Bid Bulletin #01

PROJECT: Skinner Early Childhood Center
Bid Package #2
Omaha, NE

ADDENDUM B

Structural Package
Skinner Early Childhood Center
Omaha, Nebraska
RDG Project No. 2014.128.00, File 35.1

S01.01

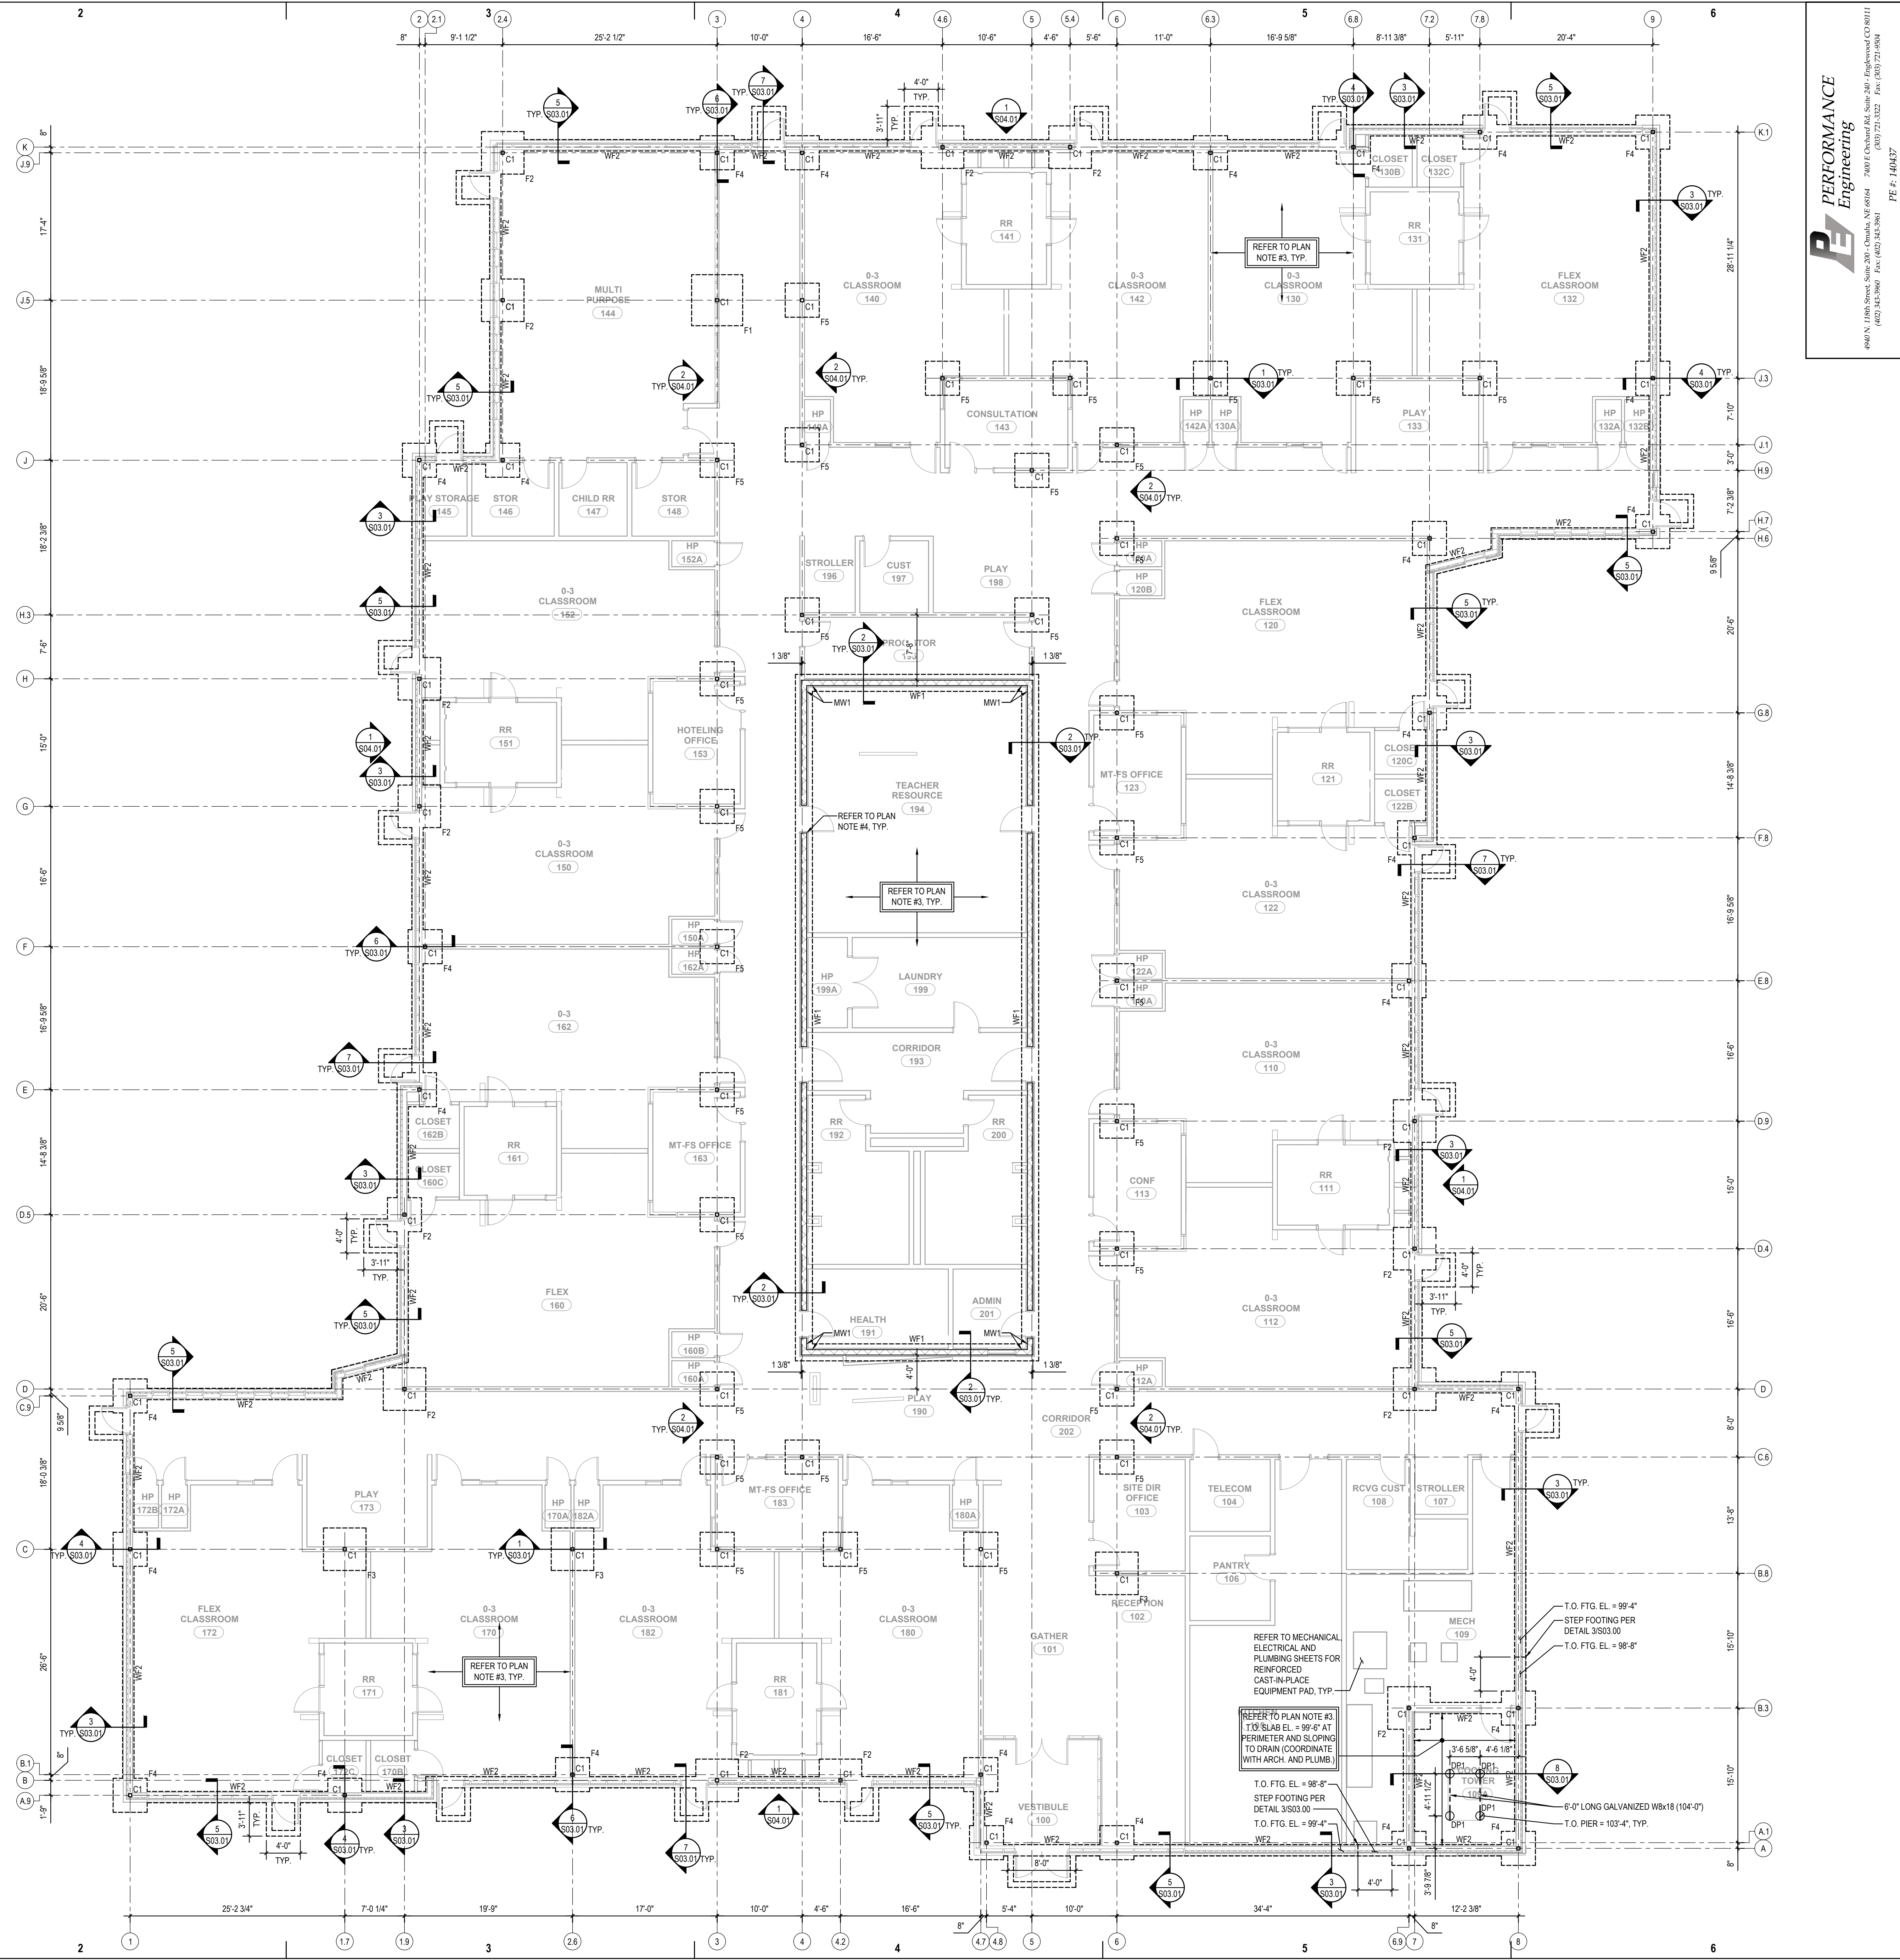
Sheet S01.01: Add Plan Note #7 as follows:

- 7. AT CONTRACTOR'S OPTION, INTERIOR FOOTING DEPTHS MAY INCREASE FROM 1'-4" TO 3'-4" WITH A TOP LAYER OF REINFORCING MATCHING THE BOTTOM LAYER OF REINFORCING TO ALLOW FOR COLD WEATHER CONSTRUCTION.**

- REFER TO SECTION 8/S03.01 FOR REINFORCED CAST-IN-PLACE CONCRETE FOOTINGS AND REINFORCED MASONRY WALLS AT DUMPSTER ENCLOSURE.
 - AT CONTRACTOR'S OPTION, INTERIOR FOOTING DEPTHS MAY INCREASE FROM 1'-4" TO 3'-4" WITH A TOP LAYER OF REINFORCING MATCHING THE BOTTOM LAYER OF REINFORCING TO ALLOW FOR COLD WEATHER CONSTRUCTION.

SKINNER EARLY CHILDHOOD CENTER
2014
RDG Planning & Design
GENERAL STRUCTURAL NOTES AND DETAILS
S03.00

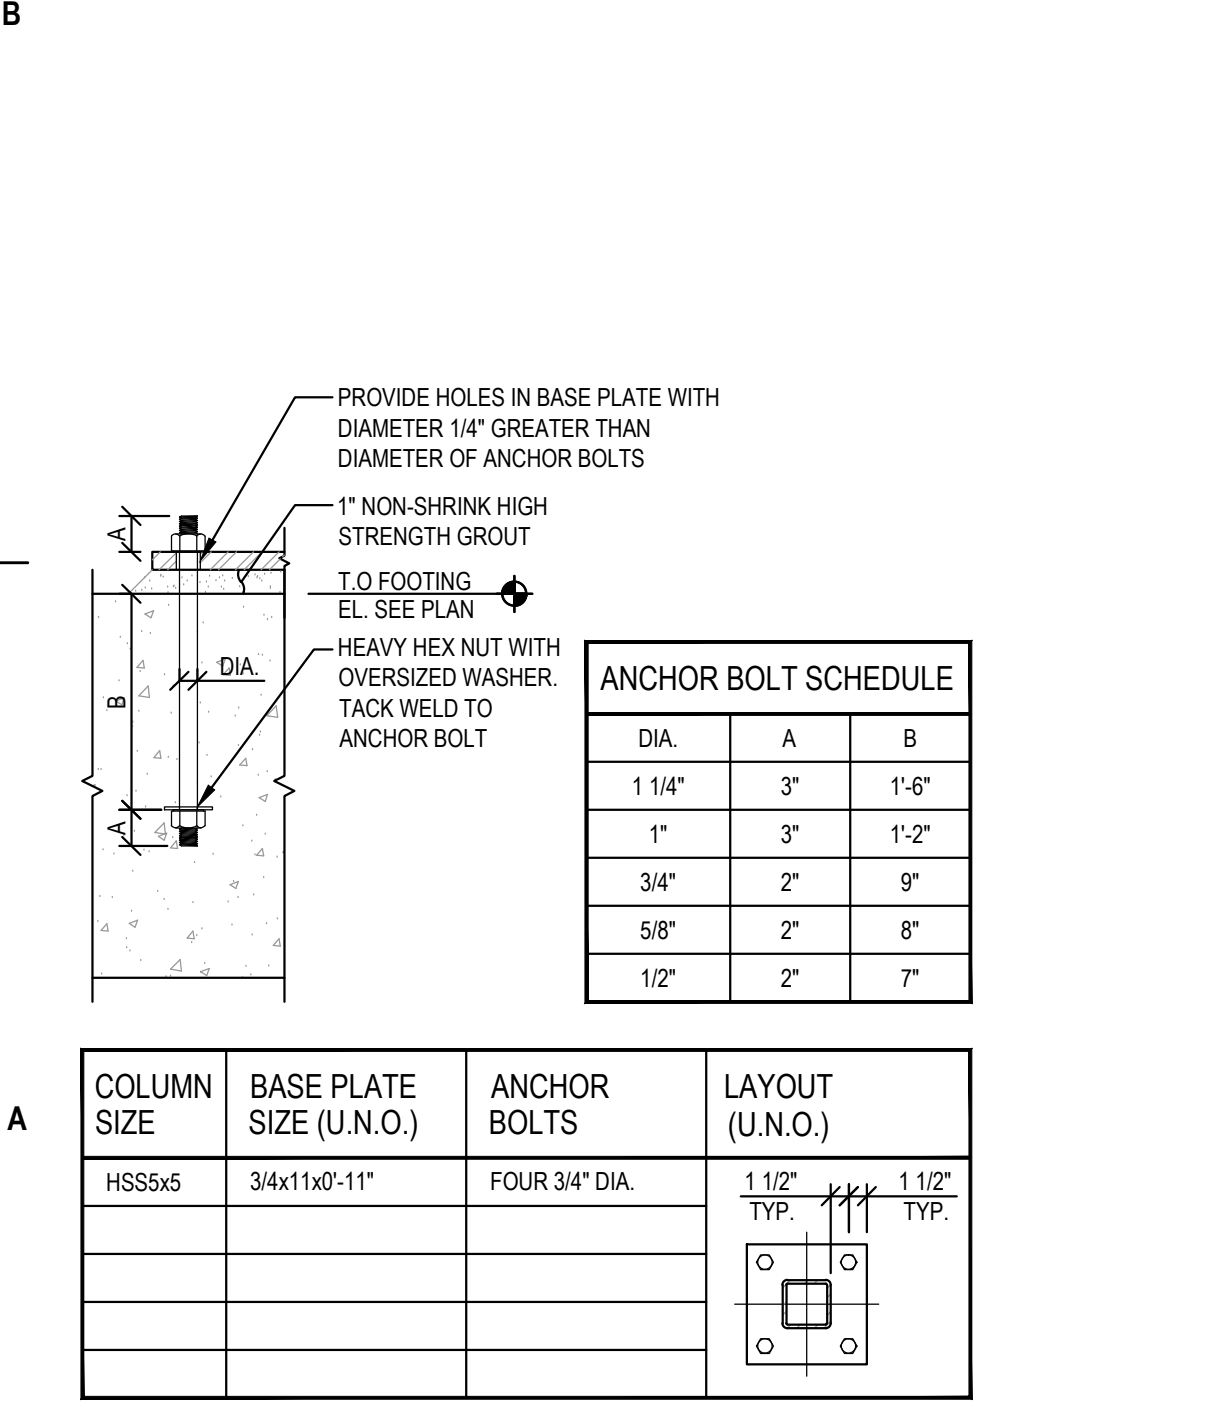
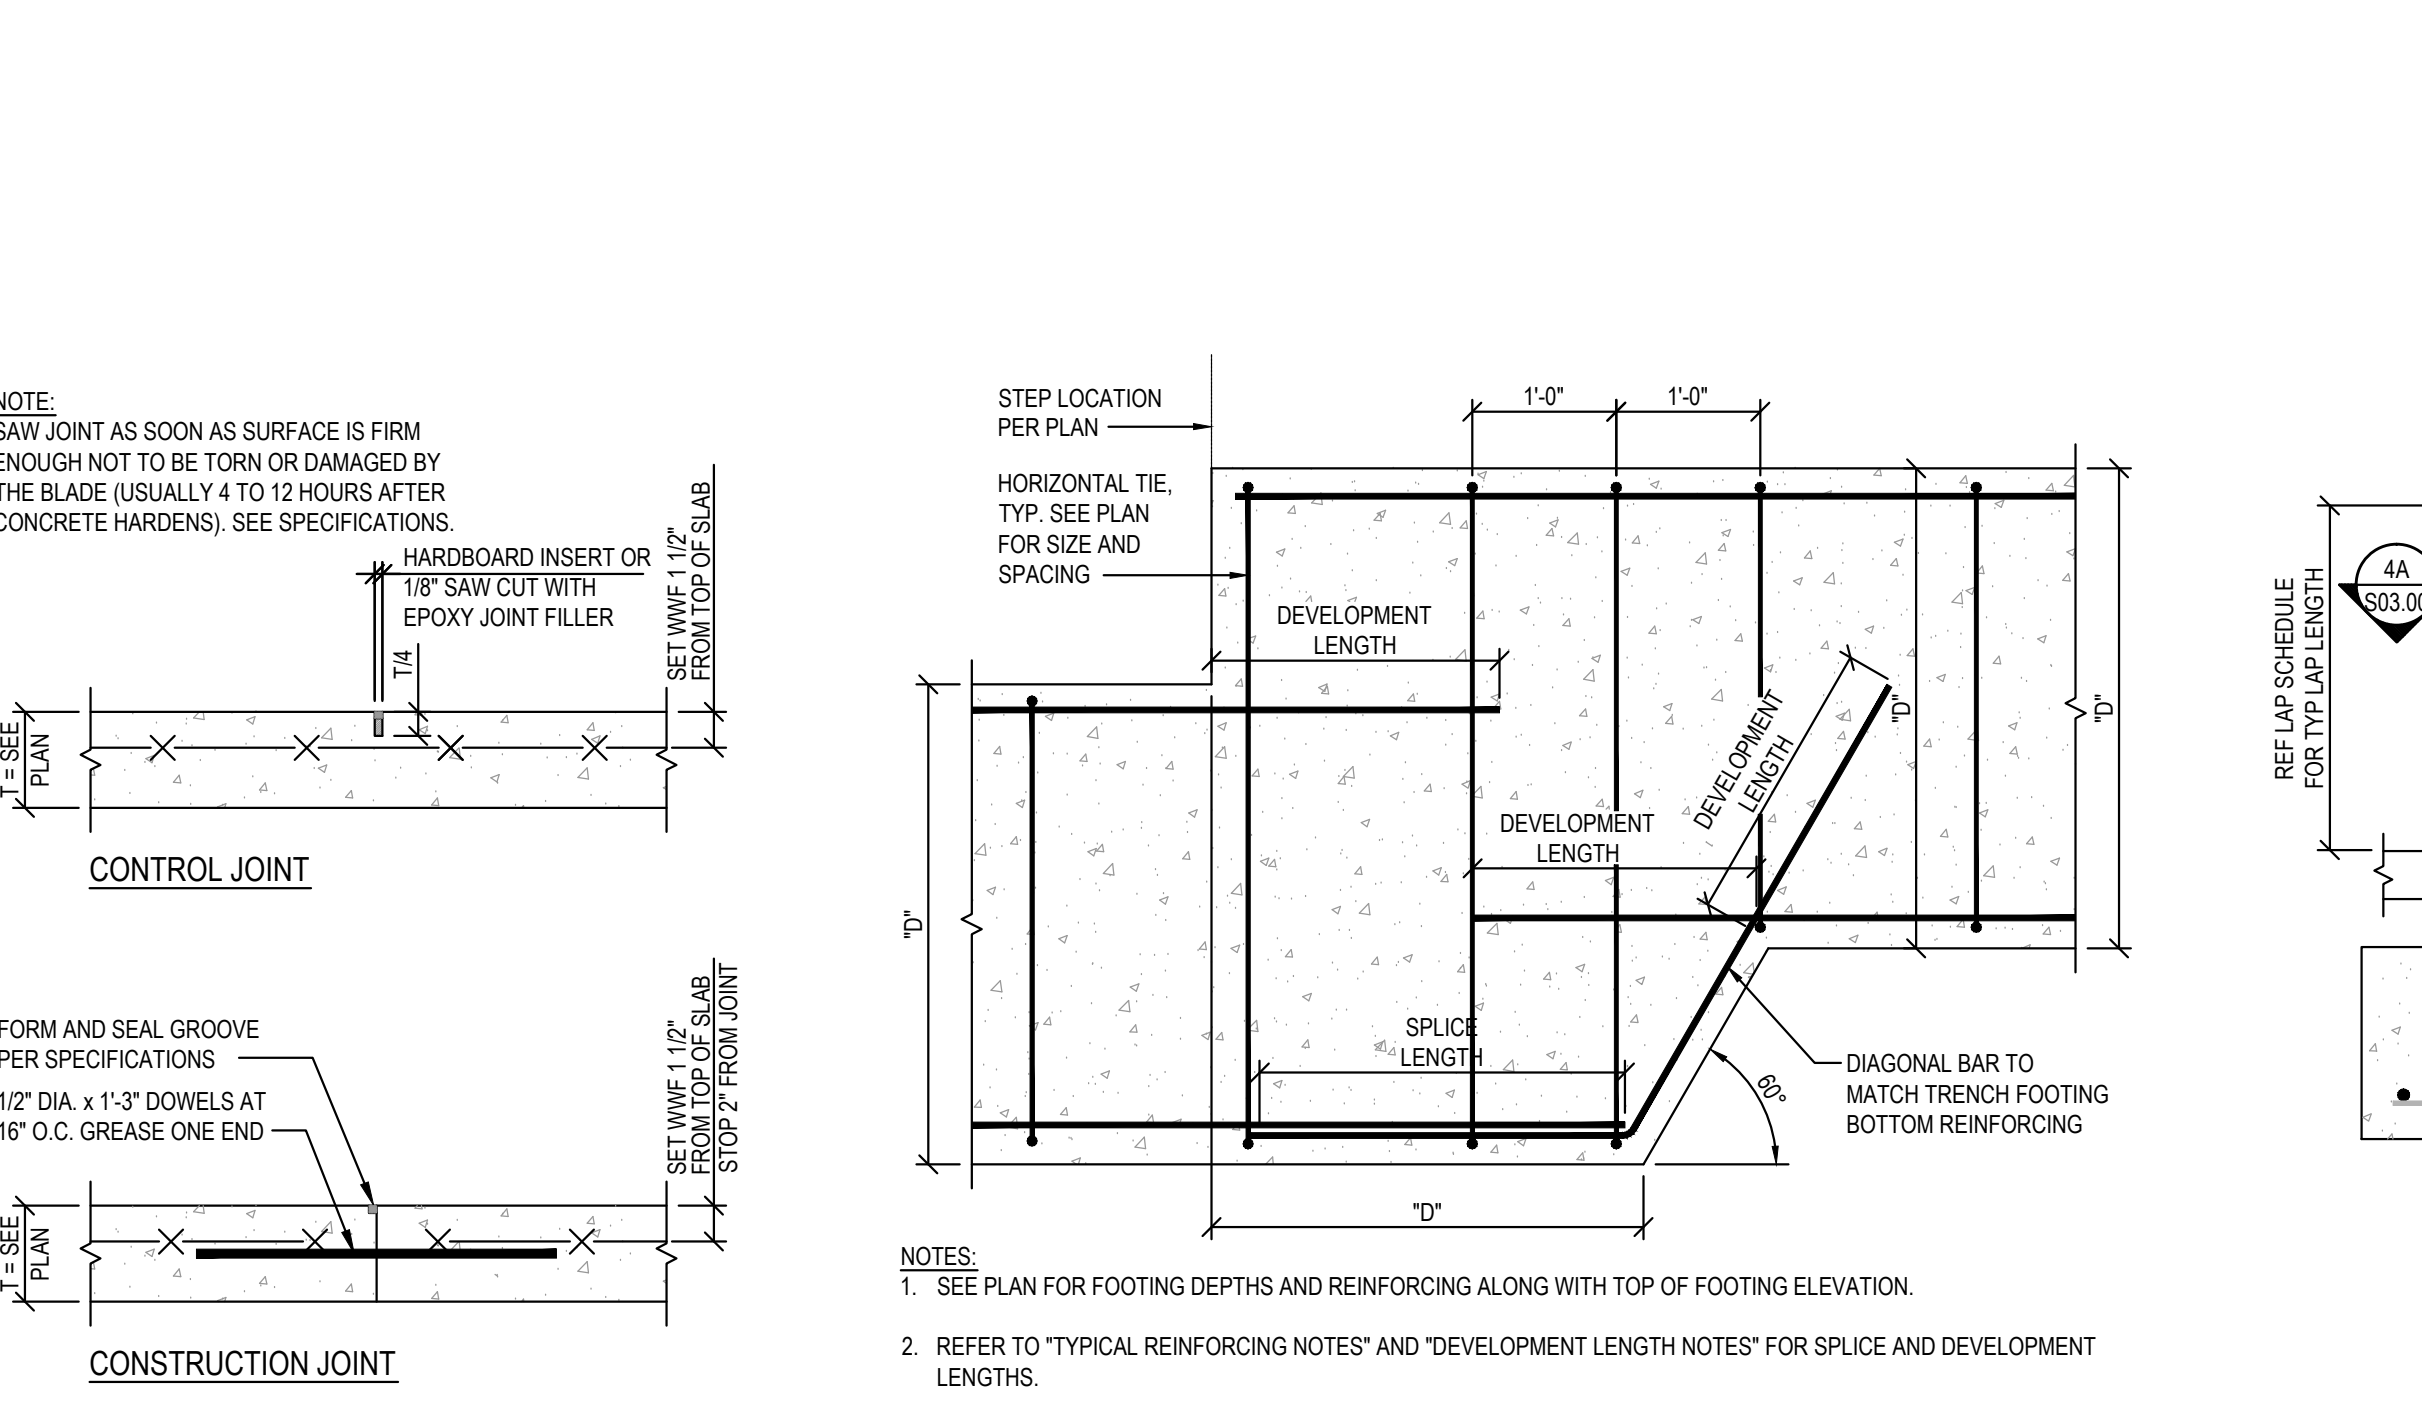
Sheet S03.00:

- A. Revise General Structural Note under Design Loads to read as follows:

- B. Revise General Structural Note C.5 as follows:

- C. Revise General Structural Note H.5 as follows:

LIVE LOADS = 25 PSF.

5. MECHANICALLY VIBRATE ALL CONCRETE INCLUDING SLABS ON GRADE.

5. WELD STEEL DECK TO STRUCTURAL STEEL MEMBERS WITH MINIMUM 5/8" DIAMETER PUDDLE WELDS AT EVERY DECK RIB AT DECK ENDS AND LAPS; FASTEN AT EVERY OTHER DECK RIB AT INTERMEDIATE LOCATIONS. #12 TEK SCREWS MAY BE USED IN LIEU OF WELDING AT THE CONTRACTOR'S OPTION. FASTEN STEEL DECK SIDELAPS WITH #10 TEK SCREWS, BUTTON PUNCH OR 1 1/2" SEAM WELD AT 24" ON CENTER.

3 PERIMETER WALL FOOTING SECTION
S03.07 SCALE: 3/4" = 1'-0"

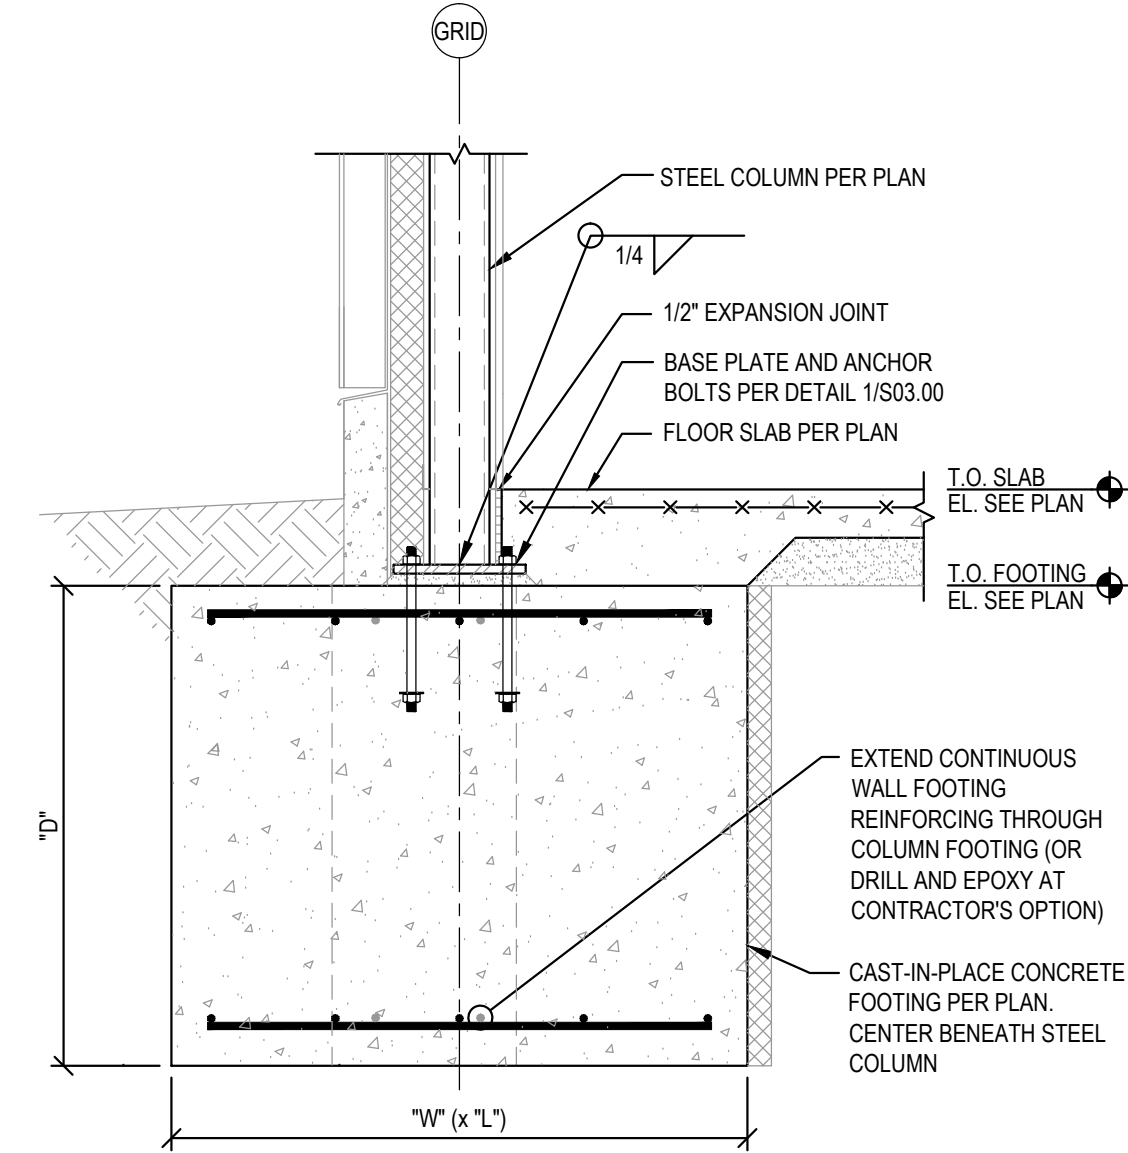
A. Section 3 – PERIMETER WALL FOOTING SECTION: Revise track-to-stem wall connection as follows:

1 1/2" DEEP CONT. TRACK MATCHING STUD WIDTH AND GAUGE WITH TWO 1/4" TAPCON ANCHORS WITH 1 1/4" EMBEDMENT AT 32" O.C. AND 4" GAGE.
